CITRUS WATERWORKS, INC.

Re: Docket No. 20250140-WU - Application for quick-take amendment of Certificate No. 684-W to add territory in Citrus County by Citrus Waterworks, Inc.

Citrus Waterworks, Inc. (Citrus) hereby submits its first initial response to Staff's Deficiency Letter dated December 16, 2025. After discussions with Staff, it was discovered that the previously approved service territory in Order No. PSC-2025-0041-PAA-WU, issued February 6, 2025 may have been incorrect. As evidence, the attached territory map obtained from the previous owner shows there have been customers on streets outside of the two subdivisions, as well as the existing general service customer since at least 1999. This map was compiled by a state certified engineer in 1999 showing these customers were already being served. Citrus has reached out to the engineering firm; however, these files have been transferred to another firm and are archived. Citrus is attempting to work with this engineering firm to obtain these records. This may take some time due to the holidays. If this is unsuccessful, Citrus will attempt to have U.S. Water Services write a territory description for this area being served bac

WATER DISTRIBUTION SYSTEM

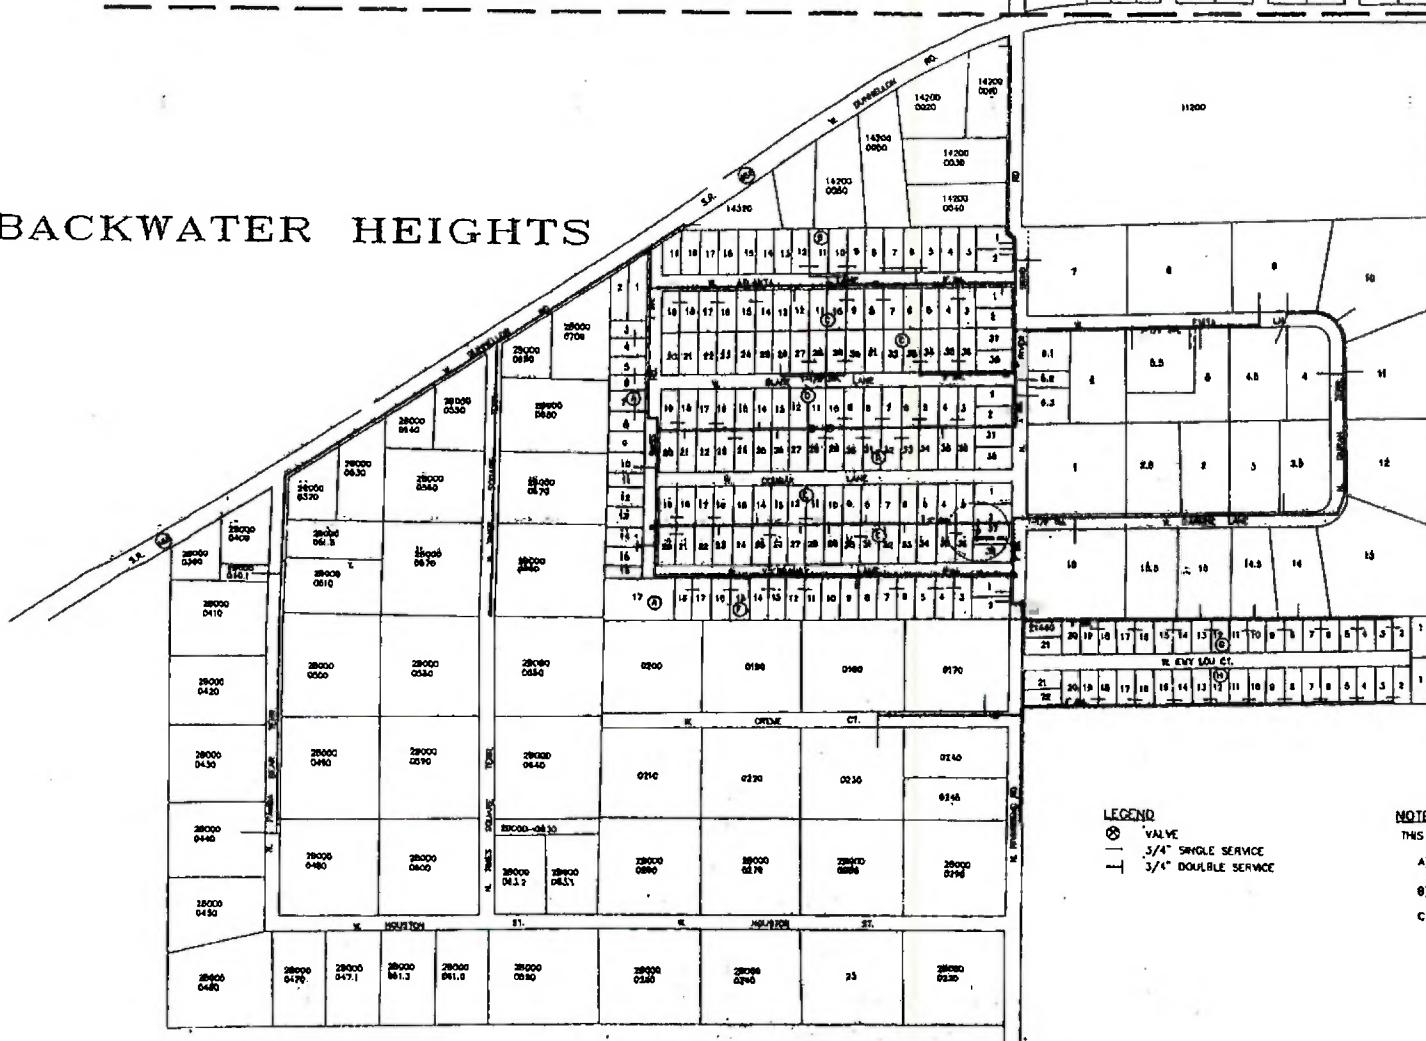
4. **Territory Map.** Rule 25-30.036(2)(h), F.A.C., requires an official county tax assessment map or other map showing township, range, and section, with a scale such as 1" = 200' or 1" = 400', with the proposed territory plotted thereon, consistent with the legal description provided pursuant to Rule 25-30.029, F.A.C. Please provide the required territory map based upon the corrected legal description.
5. **Response:** The revised territory map will be submitted once additional information is obtained from the engineering company. This will be based upon the 1999 water distribution map.

Response: The revised legal description will be submitted once additional information is obtained from the engineering company. This will be based on the 1999 water distribution map.
